3482
 SL-070645
 U-084923
 (UT-923)

AUG 25 2004

Re: Minor Modification of Resource Recovery and Protection Plan (R2P2), 1st, 2nd, and 3rd
 Left off 3rd North Mains Longwall Block, Blind Canyon Seam, Deer Creek Mine.

ENERGY WEST MINING COMPANY	
HUNTINGTON, USA#1 84828	
DEER CREEK MINE 3RD NORTH	
BLIND CANYON SEAM - R2P2 MAP - REVISED	
DESIGNED BY:	K.S. Fleck 1
SCALE:	1" = 500'
DATE:	06/03/04
SHEET:	1 of 1
REV:

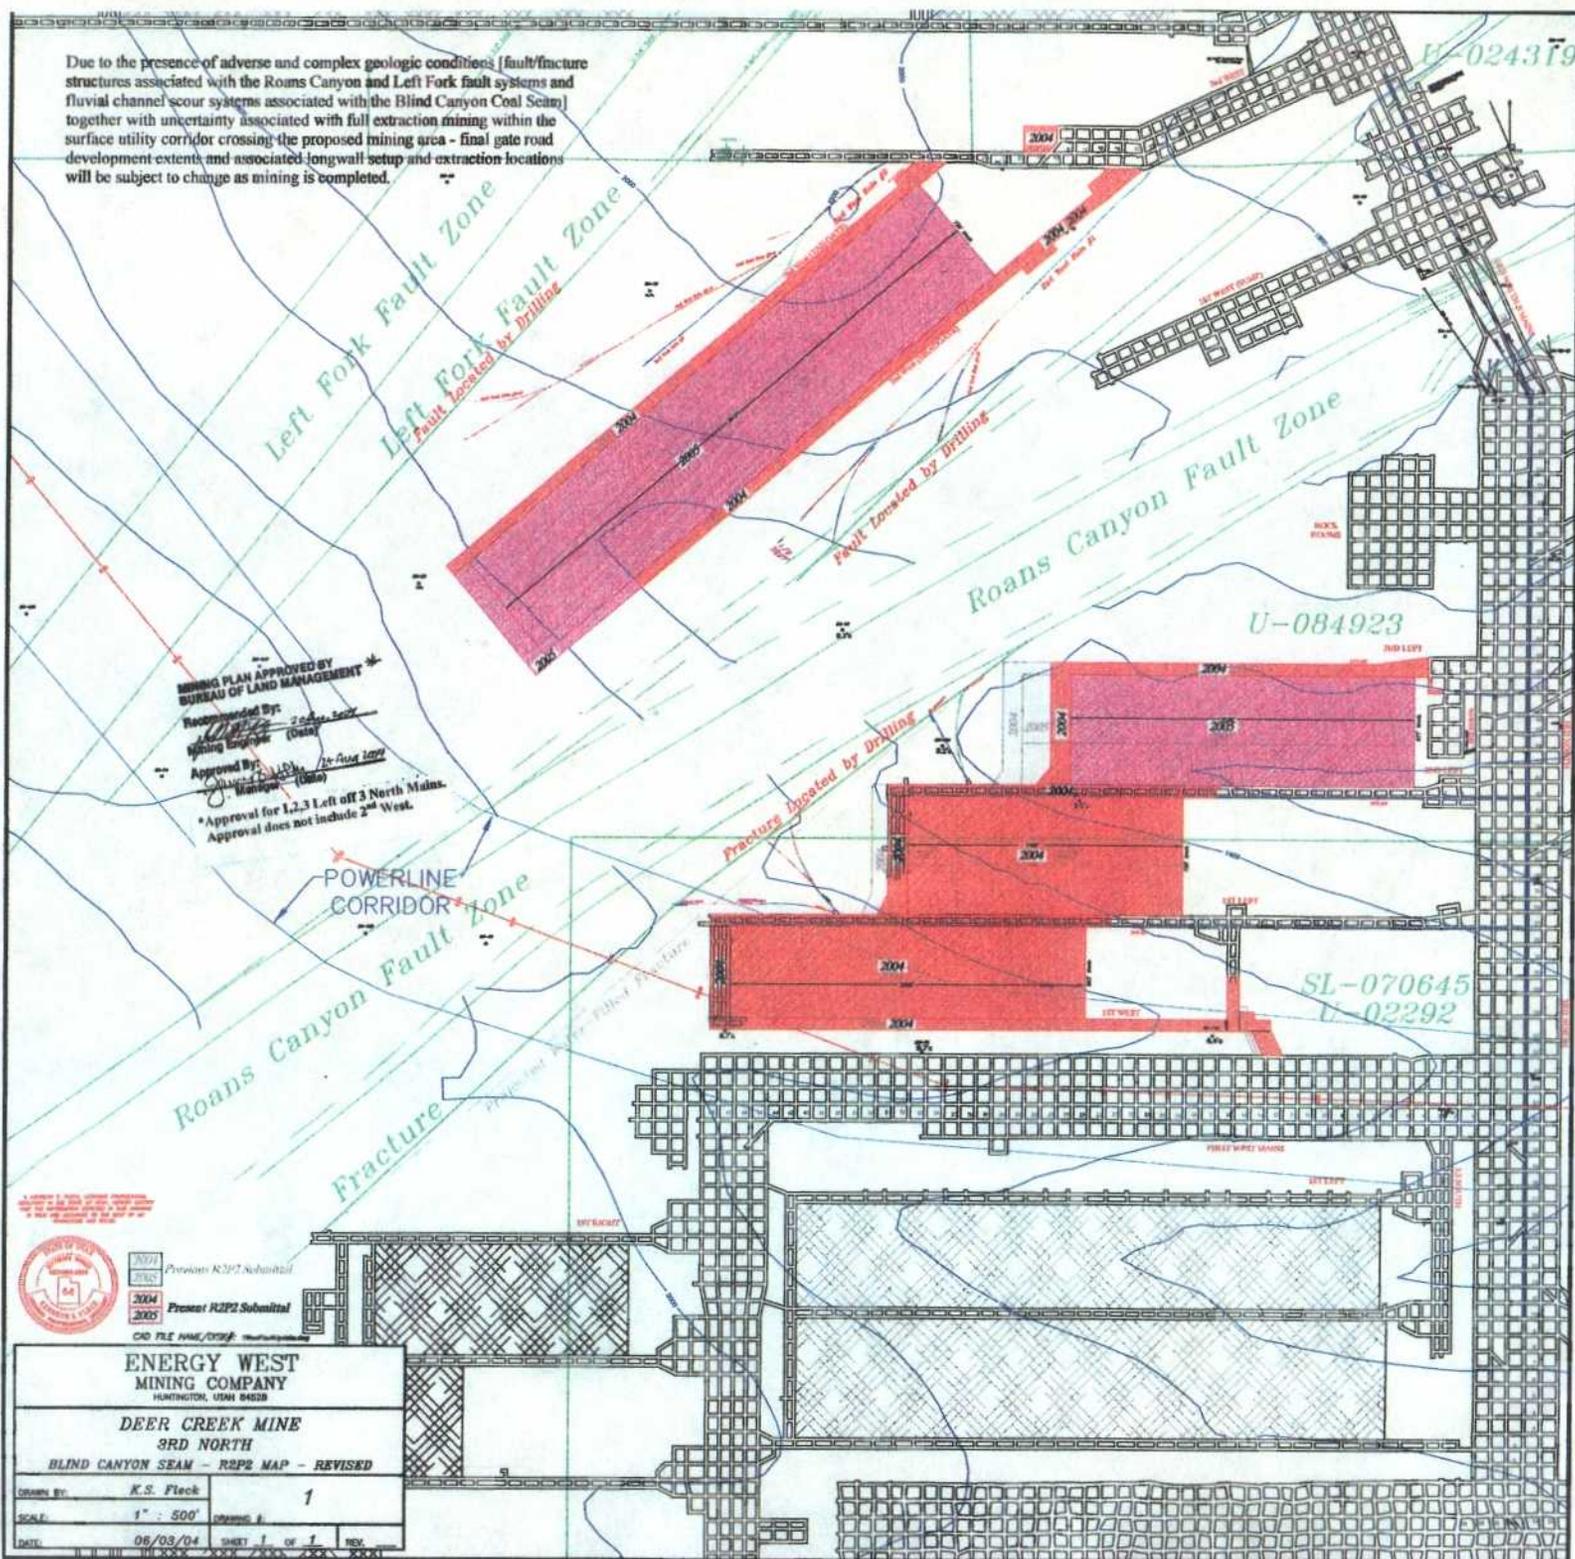
Due to the presence of adverse and complex geologic conditions (fault/fracture structures associated with the Roams Canyon and Left Fork fault systems and fluvial channel scour systems associated with the Blind Canyon Coal Seam) together with uncertainty associated with full extraction mining within the surface utility corridor crossing the proposed mining area - final gate road development extent and associated longwall setup and extraction locations will be subject to change as mining is completed.

*Approval for 1,2,3 Left off 3 North Mains.
Approval does not include 2nd West.

The modification of the R2P2 complies with the Mineral Leasing Act of 1920, as amended, the regulations at 3480, and the lease terms and conditions and will achieve maximum economic recovery of the federal coal. The modification to the R2P2, as depicted on Map CM-10899-DR revised 3-9-04, is approved as submitted. A copy of the approved mine map is enclosed. If you have any questions, please contact Stephen Falk at the Price Field Office (435) 636-3605 or Jeff McKenzie of my staff at (801) 539-4038.
